EXH. JAD-4
OREGON PUC, ORDER NO. 24-156, NO. LC 81

**BEFORE THE PUBLIC UTILITY COMMISSION
OF OREGON**

2023 Integrated Resource Plan.

ORDER

Figure 1: Comparison of Green Hydrogen Cost Trajectories

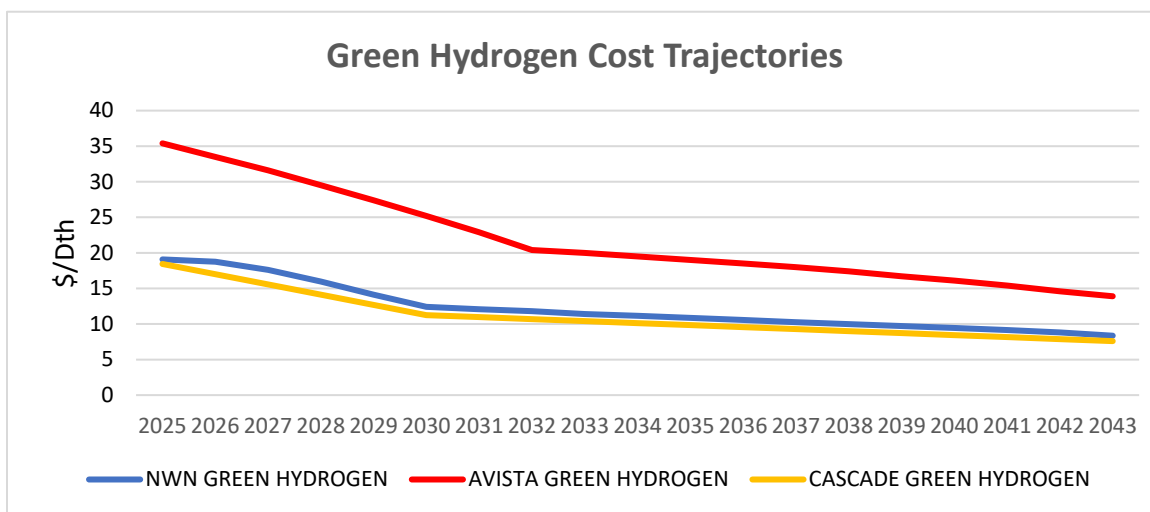
Staff agrees with CUB’s assessment of the risks associated with synthetic methane, however, differs slightly regarding CUB’s assertion that Avista needs to rely on an “established method.” Staff supports Avista’s efforts to project new supply side resource costs and availability and encourages Avista to explore and critique objective third-party sources that could be used to project costs and availability as part of the TAC process for developing future IRPs. While Avista’s estimates for green hydrogen costs as a feedstock to synthetic methane are conservative when compared against NW Natural and Cascade, as shown in Figure 1,⁷ Staff remains concerned about the Company’s ability to produce or procure the green hydrogen required to produce synthetic methane at the scale projected by Avista in its IRP.

*Figure 2:
Comparison of
Dairy RNG IRP
Estimate and RFP
Bids*

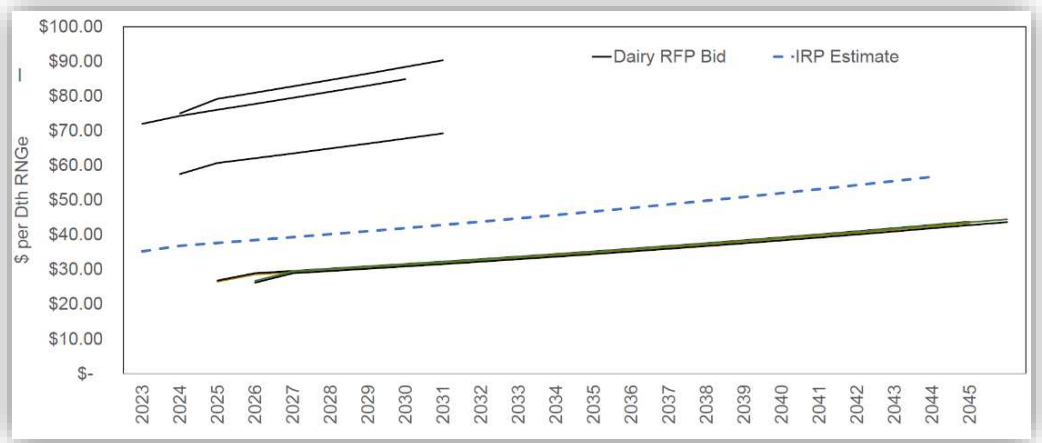
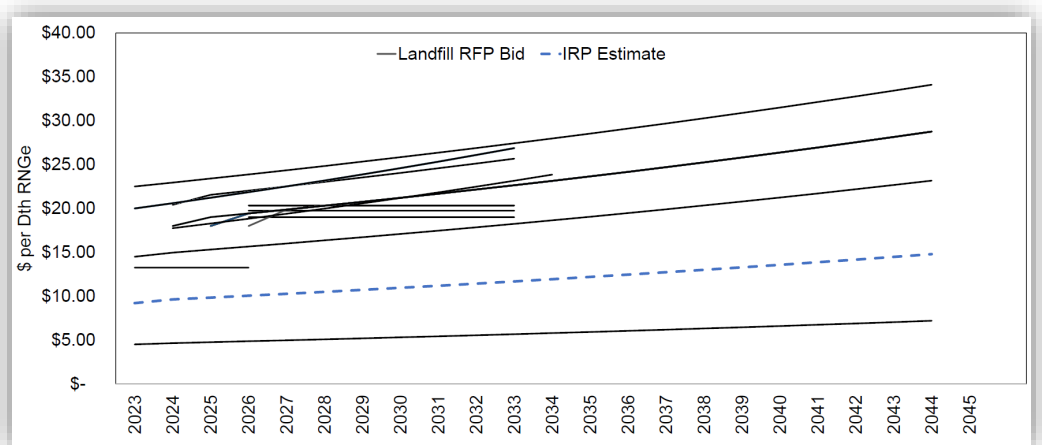
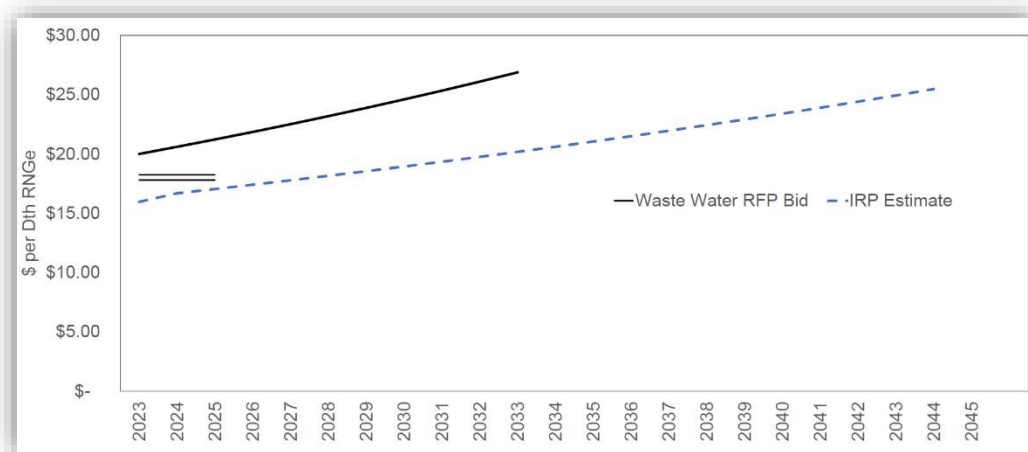
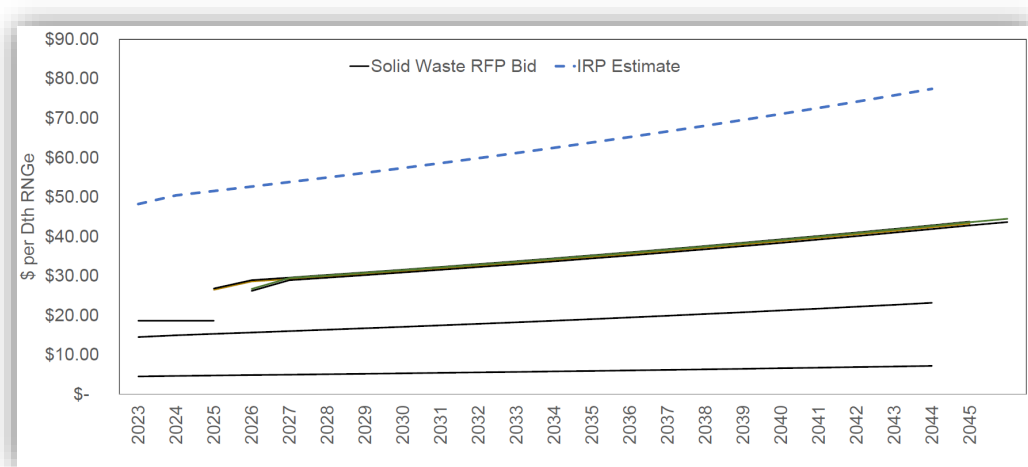
Avista addresses Staff’s request regarding how cost assumptions have changed since the 2018 Black & Veatch report by providing four charts comparing RNG pricing of the “IRP Estimate” derived from the report versus RFP bids Avista received.²² Of the four charts, only Avista’s solid waste IRP estimate is perceivably higher than then RFP bids. Avista’s IRP estimate for landfill and wastewater RNG is much lower than at least a majority, if not all the RFP bids. Dairy is likely closer to the middle of pricing based on the RFP bids, but without detailed workpapers, also appears perceivably lower than average. Avista states that the RFP prices consider market factors including Low Carbon Fuel Standard (LCFS) and Renewable Identification Number (RIN) program in the bid price.

Staff agrees with CUB that the RNG pricing is unreasonably low and that this undermines the Oregon PRS and IRP long-term plan generally.²³ While RNG is not the Company’s primary CPP compliance resource, it remains a consistently large resource in the PRS, starting in the near-term and maintaining importance throughout. If the resource is being underpriced, this could have negative impacts particularly on utilization of CCI and DSM programs, each of which represent smaller portions of the resource mix. The RNG cost comparison charts provided by Avista reinforces this concern. IRP RNG pricing that does not include important market factors, including LCFS and RIN program pricing, are unreasonably low and do not accurately represent the cost of RNG, therefore, lead to RNG to potentially overcrowding the Company’s Oregon PRS

Figure 6: NW Natural meter counts showing the return of a 2011-2015 trend of where meters decline in Q2-Q3 before rebounding in Q4 and Q1. The trailing 12-month growth rate is also at an all-time low since 2012.

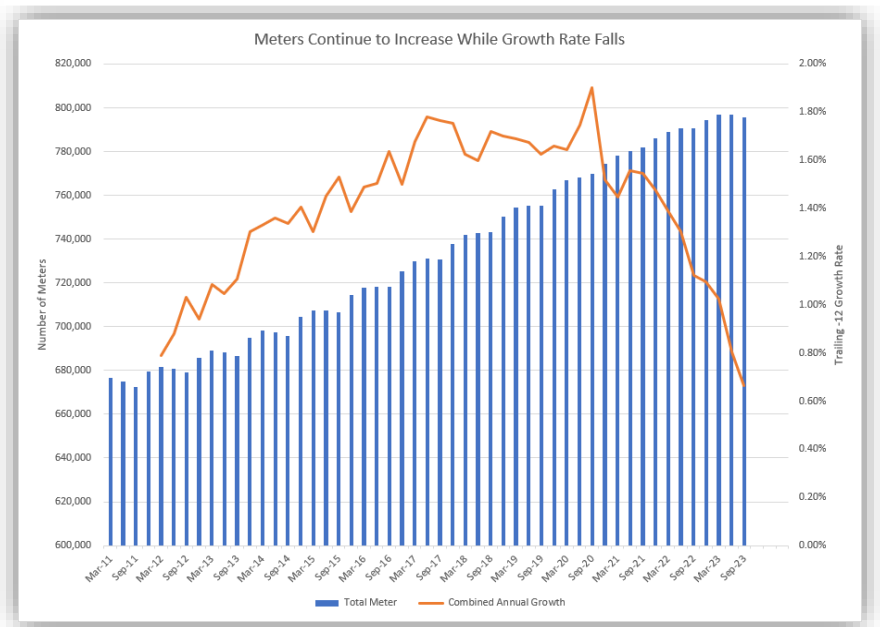
To start to understand baseline electrification occurring naturally, Staff recommends Avista use advanced metering infrastructure data and Form 10Q data to capture customer behavior. By the next IRP, Avista should present that information in the worksheet template included as Attachment B. An example of captured customer behavior from NW Natural’s Form 10Q is shown in Figure 6. This graph shows that even as meters increase, growth rate falls, suggesting increased energy efficiency measures and the natural electrification of end-uses. Such data can then be used

as inputs in econometric modeling of electrification by use or by locality. Captured changes in behavior and energy use suggest that LDCs, in consultation with electric utilities, municipalities,

Figure 7: Forecast Space Heat Costs

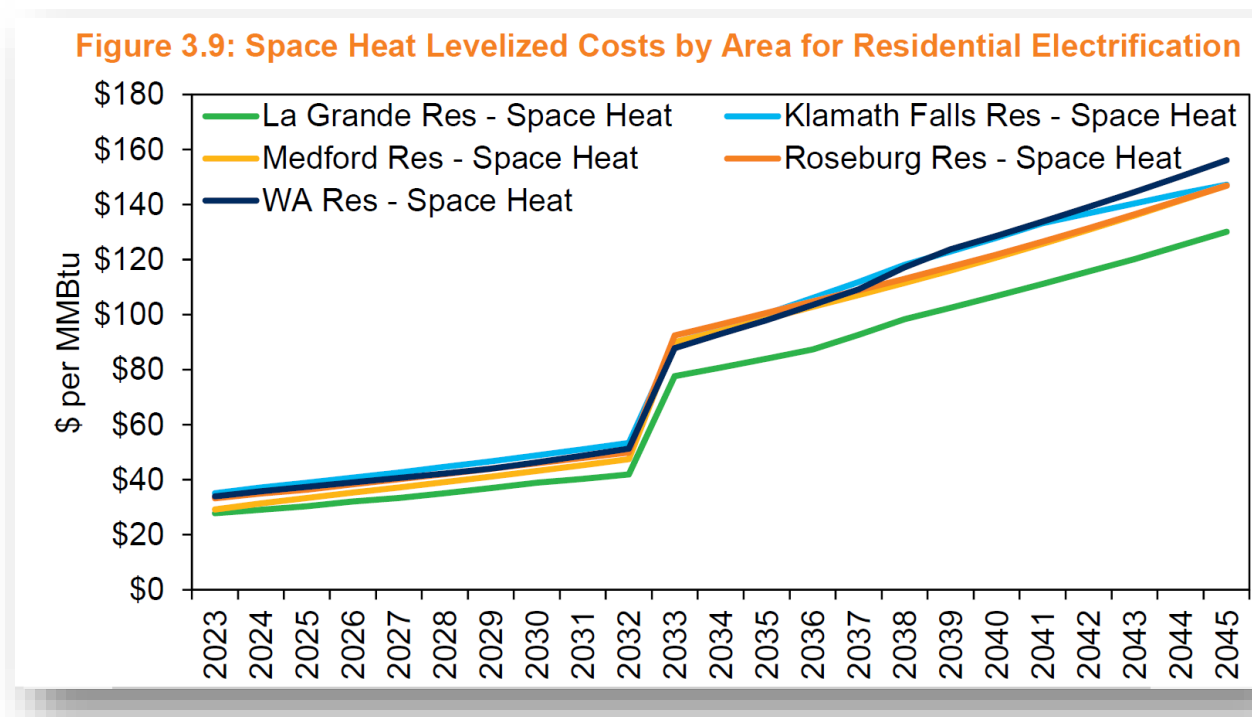
Figure 7 below shows Avista's forecasted cost for electric space heat inclusive of a 50 percent reduction in conversion costs for IRA incentives and increasing electric rates.¹⁴³
